ATTACHMENT 2

PROPOSED TECHNICAL SPECIFICATION CHANGE

NORTH ANNA UNIT NO. 2

Figure 6.2-1 Offsite Organization for Facility Management and Technical Support

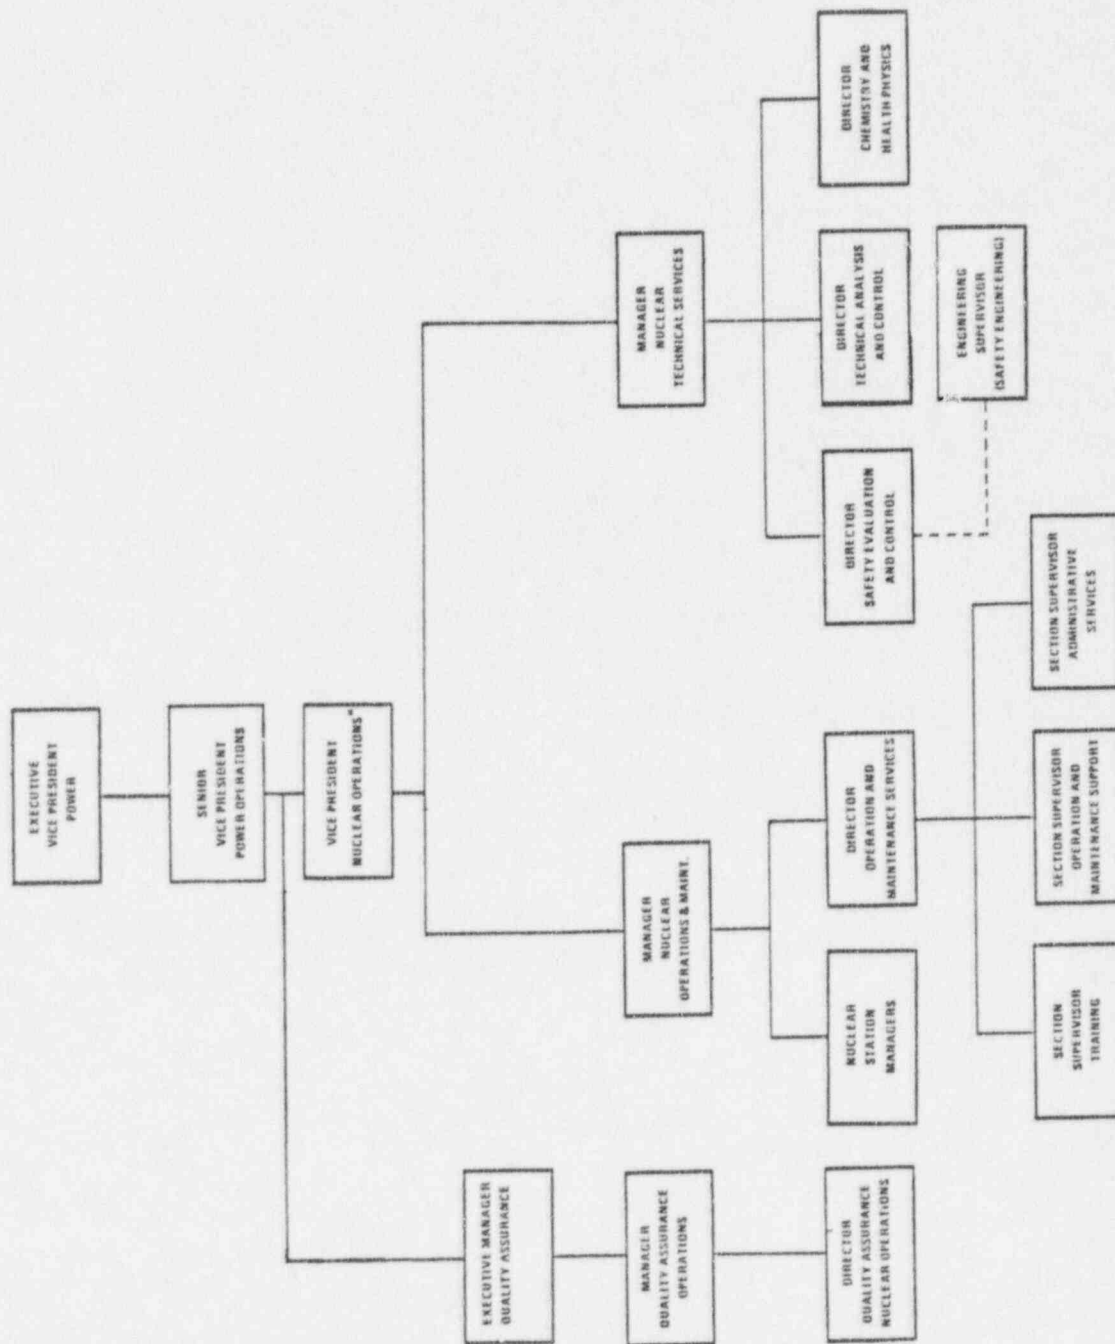
SEE ATTACHED PAGE
